**Historical Architectural Review Board  
COA Final Review Sheet**

**HDC-2023-00060**

**Address: 141 N. 10<sup>th</sup> Street**

**Proposal: Legalize removal of rear porch (violation correction)**

**Rear porch roof of 141 N. 10<sup>th</sup> Street prior to removal, 2019.  
(Google StreetView)**

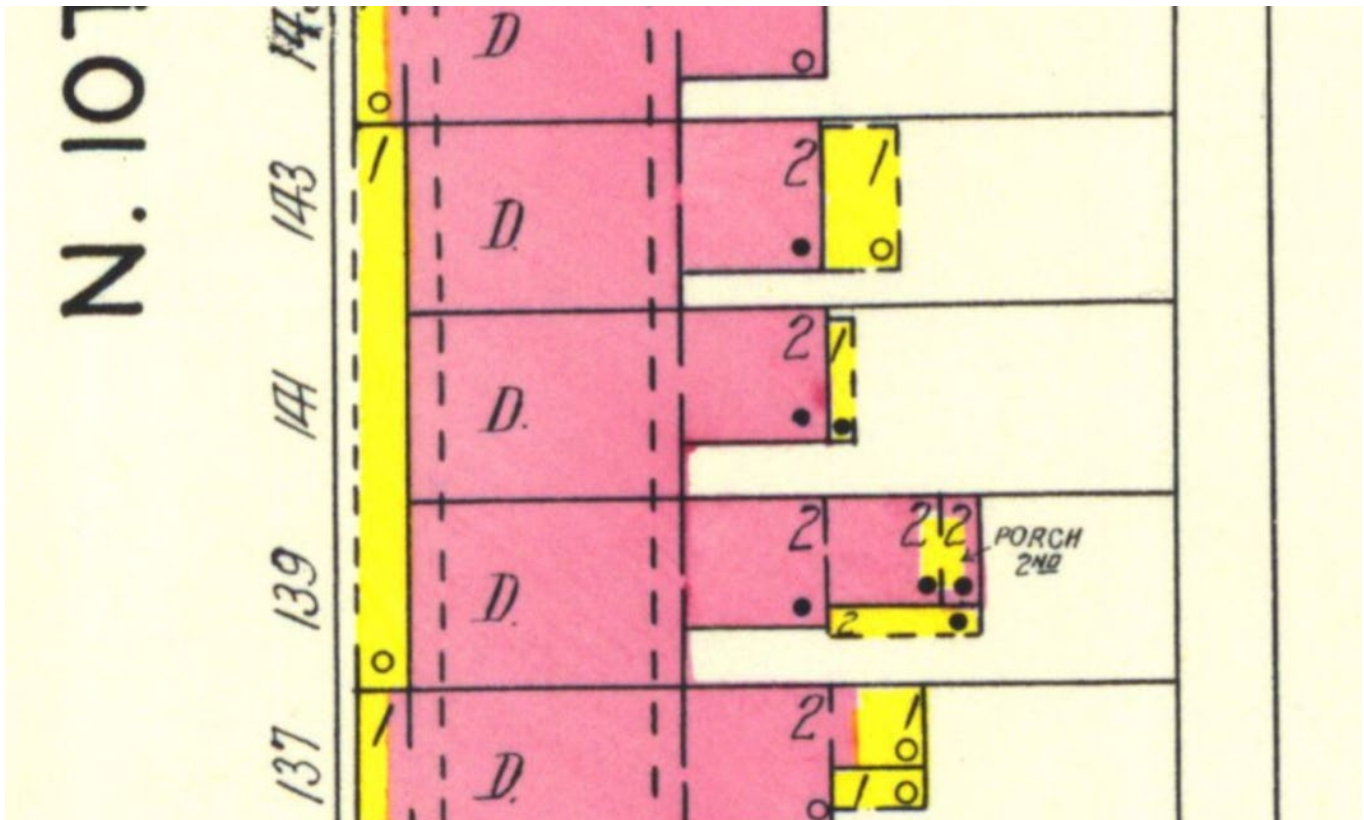
Though located at the rear of the building, the one-story porch was highly visible from the public right-of-way because of its proximity to the Allentown Cemetery, which is located immediately across Hazel Street. The porch also had the distinctive form of the Allentown porch roof, which is the curved projecting roof installed on brackets. The owner contends that the porch roof was in poor condition and beyond repair, and that it had to be removed to comply with insurance requirements.

Staff finds that, because the porch was visible from the public right-of-way and was of the distinctive Allentown porch roof design, the porch should be replicated and reinstalled to match the original. The 1932 Sanborn map shows that the porch had a “composition roof,” and staff suggests that asphalt shingles or a similar material be used, and recommends that the roof be secured on wood brackets to match the original.

Mr. Jordan moved deny the application presented on 10/2/2023 for legalizing the removal of the rear porch roof at 141 N. 10<sup>th</sup> Street, pursuant to Chapter 3, Section 3.7 Porches & Steps. Mr. Huber seconded the motion, which carried with unanimous support.
